FTI-NSP2 Type 1 - Installation Notes & Wiring Diagram

FTI-NSP2 Type 1

Overview: The initial production release of the FTI-NSP2 harness has an issue where the POC1 circuit is incorrectly positioned in the CM7 I/O connector. This issue affects only the gray 20-pin CM7 I/O connector illustrated below in figure 1.

Figure 1: Incorrect placement

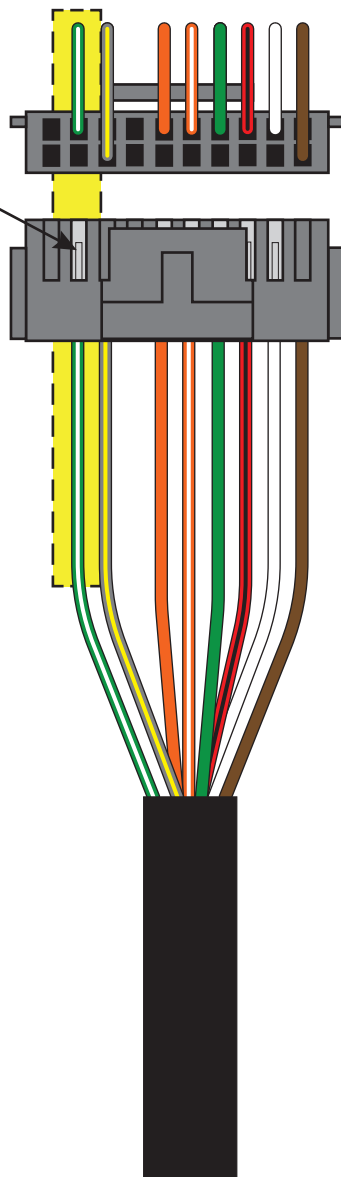
Issue: The green/white parking light circuit is positioned in pin position #17, the fixed light output where the green/white wire is typically placed for parking lights, but the harness solution uses the vehicle hazard lights instead, the result when used as supplied is an erratic light display.

- 1.) Use a pick tool to depress the locking tab on the terminal connector of the green/white wire
- 2.) Remove wire and prepare to reposition
- 3.) Once removed, reposition the locking tab by using a razor knife to lift the tab into a usable position
- 4.) With locking tab repositioned, relocate to pin position #1 (top right position as illustrated)
- 5.) Push the terminal connector into the I/O connector housing until the locking tab clicks into place and the wire is secure
- 6.) Correction complete, you may now complete the installation, but remember to configure POC1 for Hazards (setting #30)
